# Access Compliance Report

## Public Rights-of-Way

Intersection ID: 51442	Main Street: TAMARRON_DR	Cross Street: KRISTENS_MARE_DR	Location: NE
ADA ID: 413534ABF99D	Ramp Type: PerpDiag	Initial Pass/Fail: Pass	Overall Compliance: No
Severity Score: 5			
Codes/Mitigation Info/Possible Solution		Field Measurements/Component Compliance

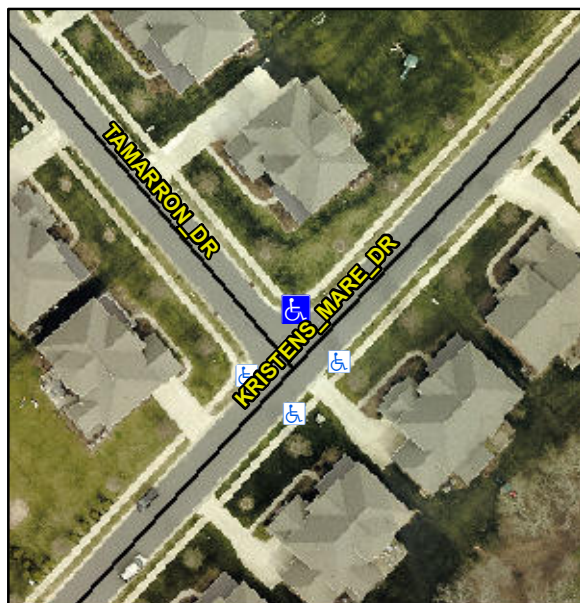
**Not Found, R304.2.1, R304.2.2-Perp, R304.3.2-Para, R305.2, R304.5.4**

Compliance	Description	Data	Compliance	Description	Data
N/A	Ramp Length (in)	46.0	Yes	Ramp Slope (%)	7.2
Yes	Ramp Width (in)	48.0	Yes	Ramp XSlope (%)	0.4
N/A	Flare Type LT	Sloped	N/A	Flare Type RT	N/A
N/A	Flare Slope LT (%)	3.5	Yes	Flare Slope RT (%)	3.6
N/A	Flare Traversable LT?	Yes	N/A	Flare Traversable RT?	Yes
No	Landing Length (in)	47.0	Yes	DWS Provided?	Yes
Yes	Landing Width (in)	48.0	Yes	DWS Contrast?	Yes
No	Landing Slope (%)	2.4	Yes	DWS Length (in)	24.0
Yes	Landing X Slope (%)	0.8	Yes	DWS Full Width?	Yes
N/A	Landing Curb? (Y/N)	No	No	DWS Offset (in)	4.5
N/A	Shared Landing?	No			
Yes	Gutter Ponding?	No	No	Gutter Slope (%)	11.6
Yes	Gutter Lip Ht (in)	0.0	Yes	Gutter X Slope (%)	0.4
N/A	Painted X Walk1?	No	N/A	Painted X Walk2?	No
	X Walk 1 Direction	To SW		X Walk 2 Direction	To SE
N/A	X Walk 1 Width (in)	N/A	N/A	X Walk 2 Width (in)	N/A
	X Walk 1 Slope (%)	3.0		X Walk 2 Slope (%)	0.8
	X Walk 1 X Slope (%)	0.1		X Walk 2 X Slope (%)	0.9

**Remove & Replace Curb Ramp With Two New Directional Ramps or Equivalent. Remove & Replace Gutter.**
